NO: 04-18

TO: Emerson Wholesalers

SUBJECT: Unloader Valve Assembly Supplier Changes

Figure 1

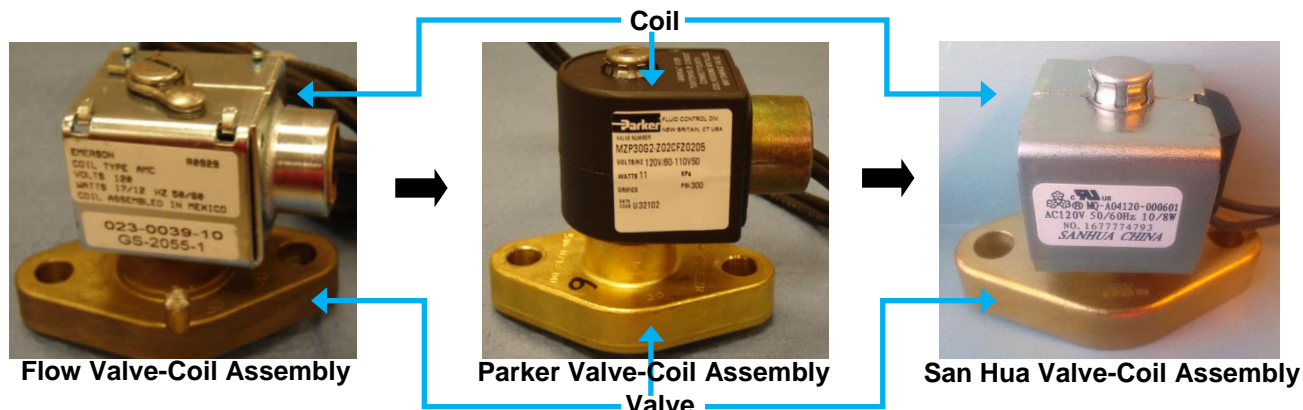
In 2013, we transitioned suppliers (from Flow Controls to Parker) for unloader (4D/6D/8D & 3D Moduload™) valve assemblies, in an effort to continuously provide the best priced capacity control hardware to our customers. This change did not affect the function of the assembly. The purchased kit numbers did not change, however the components inside the kits did carry new part numbers. We are **now** in the process of moving from Parker to San Hua, as Parker has discontinued their line of unloader valves. See Figure 1.

The Flow to Parker transition was implemented on 6/24/2013. The **NEW** Supplier transition (Parker to San Hua) began on 4/17/2017 and will be implemented on a *part-by-part* basis, as the remaining Parker inventory is consumed. Parker inventory has already been depleted for the kits shaded in **yellow** below and any new kits shipped from the Mt. Comfort Distribution Center will contain the NEW San Hua part number.

Figure 2

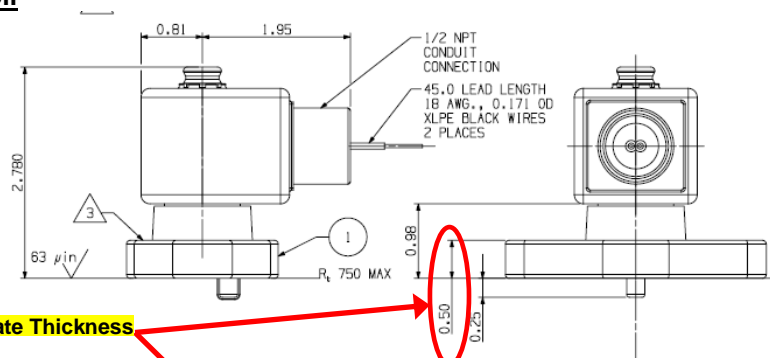
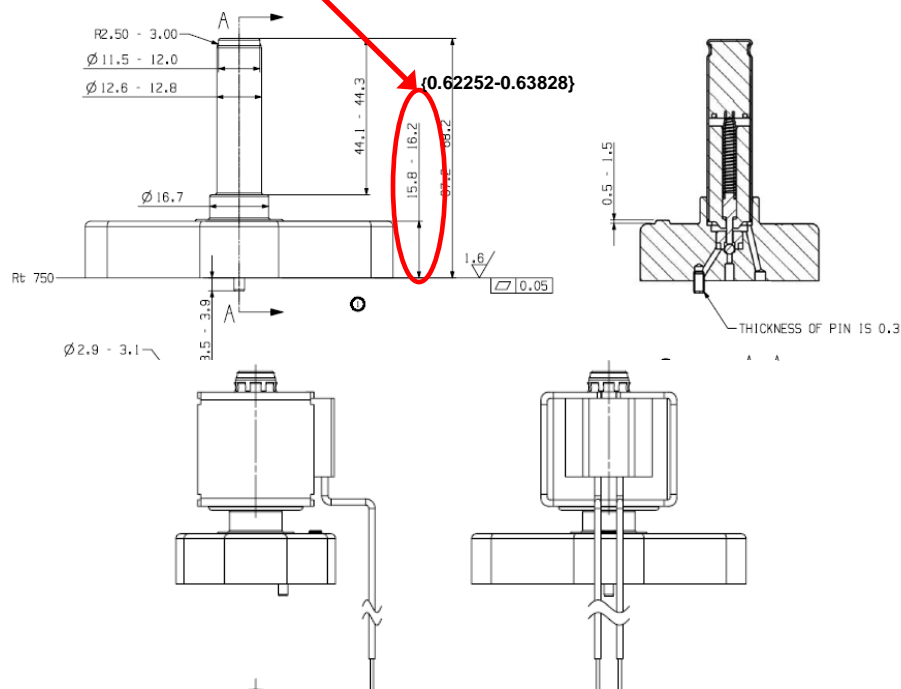
Key differences between the current Parker Valve and the NEW San Hua Valve...

- The Parker coil is in a plastic (FC) housing and the San Hua coil is in a metal casing.
- The Parker coil has 45" electrical leads and the San Hua coil has 45.28" electrical leads.

Longer Studs: Due to the 1/8" increased thickness of the San Hua valve base (see Figures 2-4), the transition from Parker to San Hua will require longer mounting studs in some kits. See Table 2. Refer to AE-1219 <https://climate.emerson.com/CPID/GRAPHICS/Types/AEB/ae1219.pdf> for torque values. We will be adding the longer studs and nuts to the affected 4D/6D 998-0212-XX Unloader

Valve Kits, 4D/4R/6D/6R Discus II (DII) Capacity Control Conversion Kits and 4D/4R Cylinder Head Kits only. We will also provide these extra studs and nuts to customers who have already received kits (containing **San Hua** valves) that were impacted by this change. 3D and Discus III (DIII) kits will not be impacted by this transition. See Tables 3-5 below for specific kits.
